PUBLIC INTEREST REVIEW FOR GROUNDWATER APPLICATIONS

TO: Water Rights Section Date April 9, 2014
 FROM: Groundwater Section Mike Zwart
 SUBJECT: Application G- 17802 Reviewer's Name Mike Zwart
 Supersedes review of _____ Date of Review(s) _____

A. GENERAL INFORMATION: Applicant's Name: Rustin Smith County: Baker

BAKE 52230

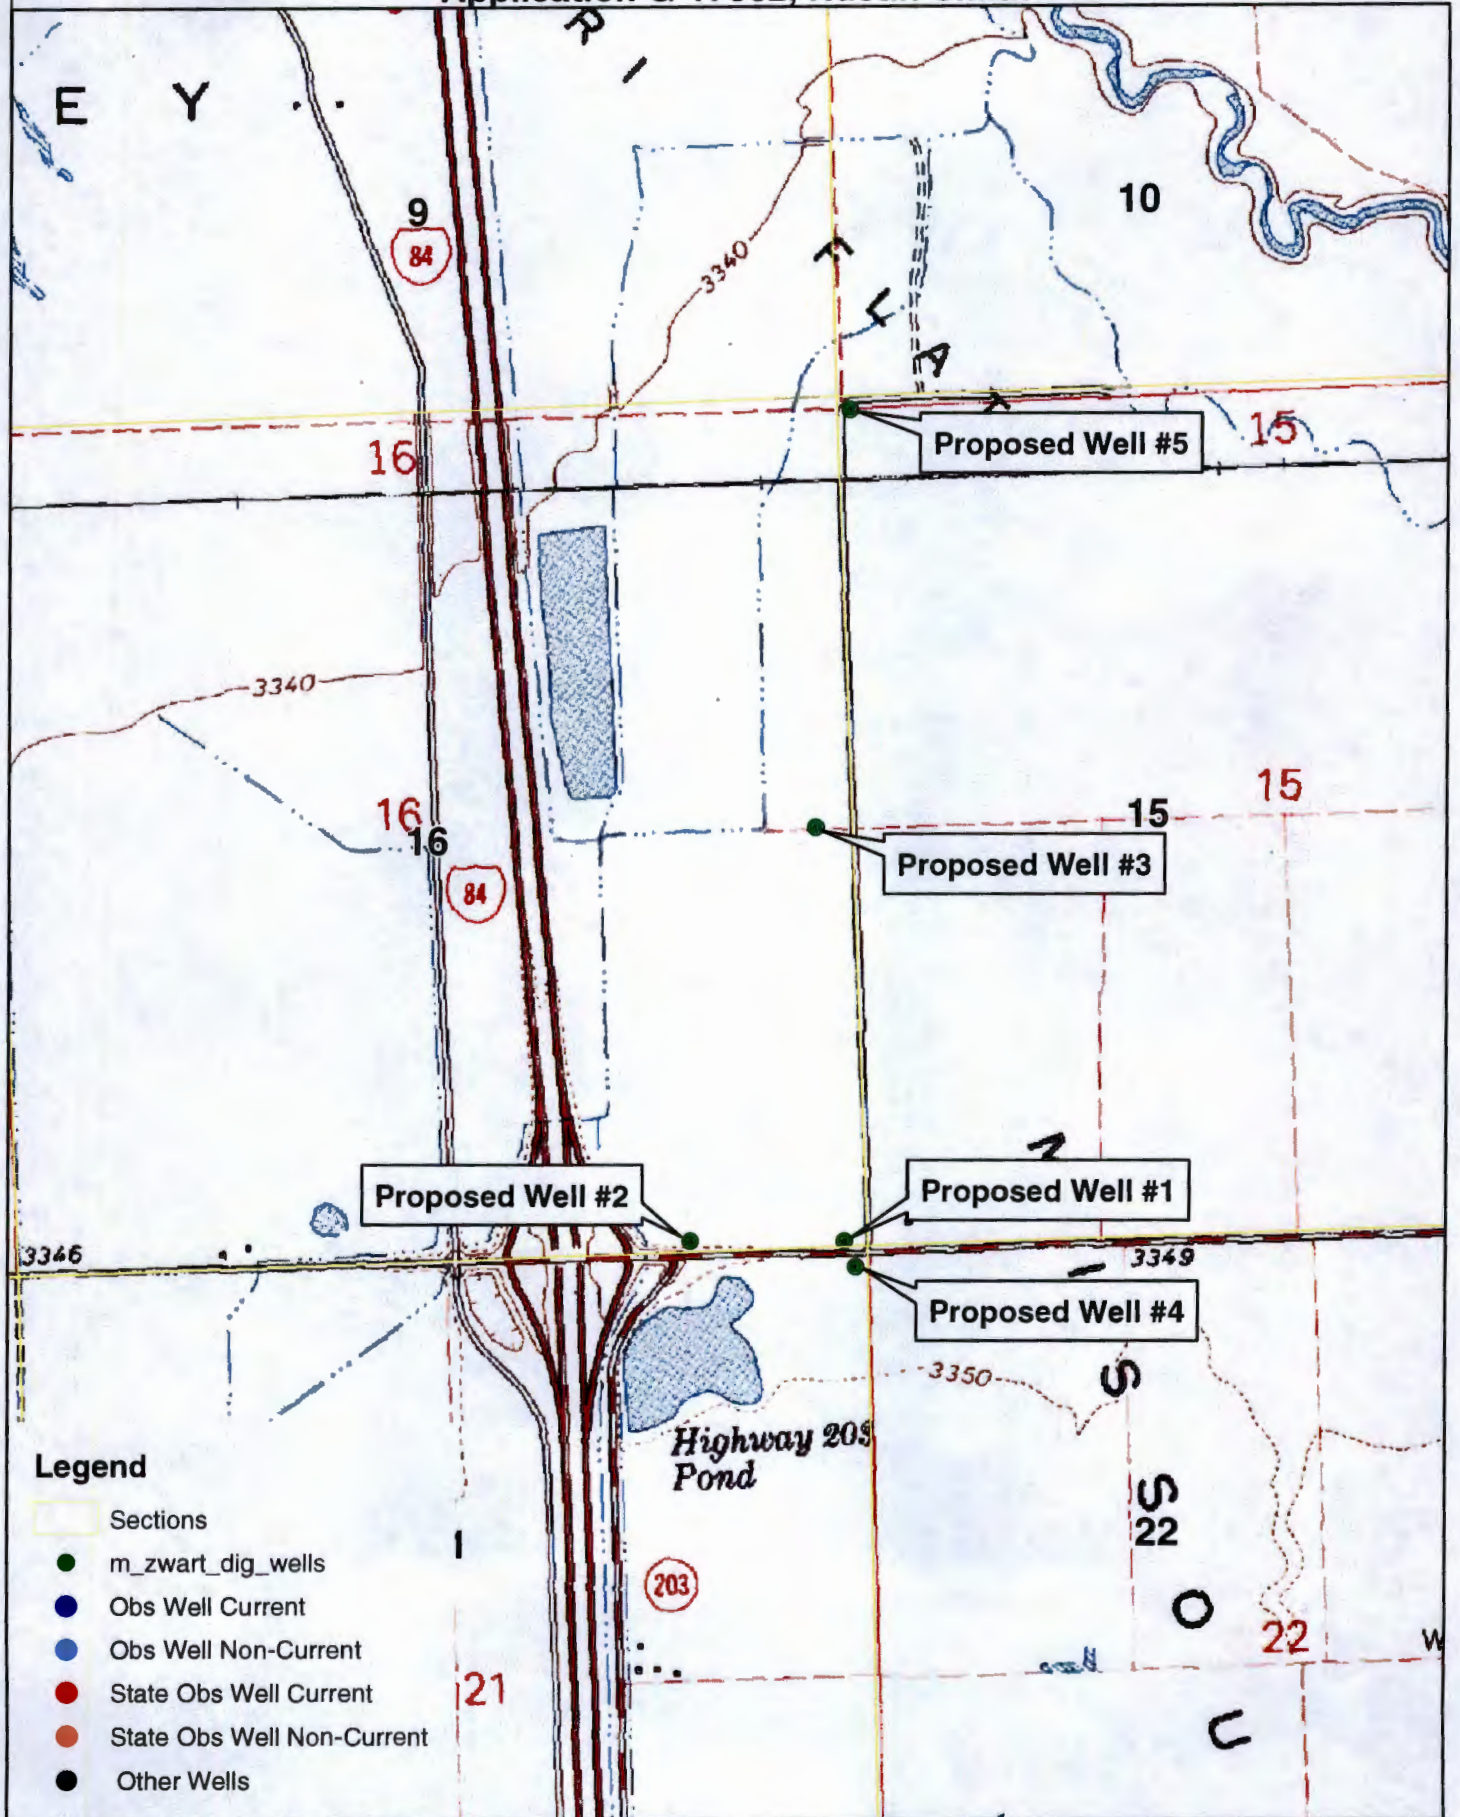
A4. **Comments: Several nearby well logs were cited as examples. BAKE 52230 is reportedly owned by the applicant and is constructed very similarly to the proposed wells here.**

Basis for aquifer confinement evaluation: Based on the local well logs and the proposed seal depth, the targeted aquifer is unconfined to poorly semiconfined. I believe that most local surface water sources, including Highway 203 Pond, reflect the head in the alluvial aquifer. BAKE 52230 reports a very shallow perched water table, but the head reportedly did not change below a depth of 27 feet.
